**Marine Safety Center Vapor Control System (VCS)  
Plan Review Information Sheet (PRIS)**

Vessel Name		Shipyard	Jeffboat
Official Number		Hull Number	03-2972 & 03-2977

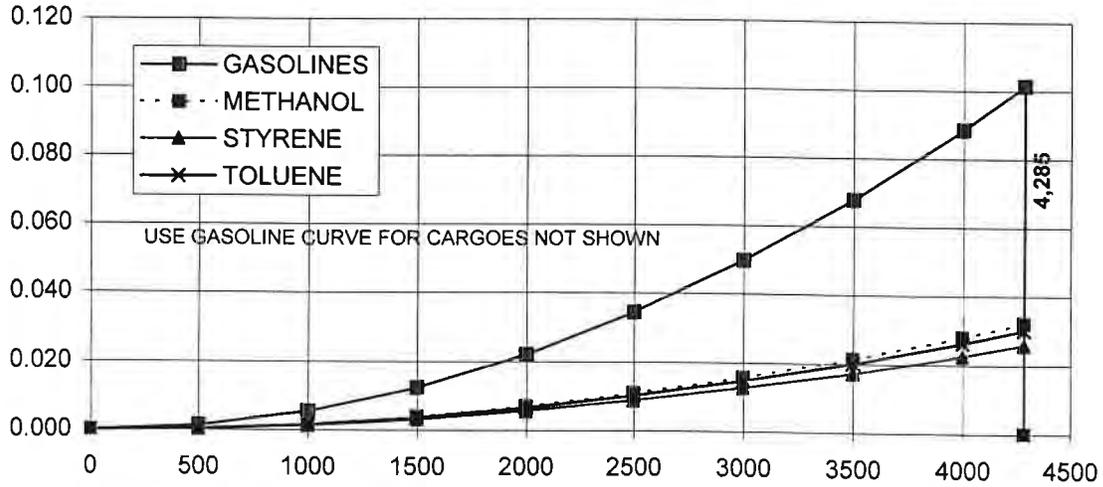
9c. Verify isolation valve at the vapor connection flange is manually operable and designed in a way it is "clearly" open or closed.
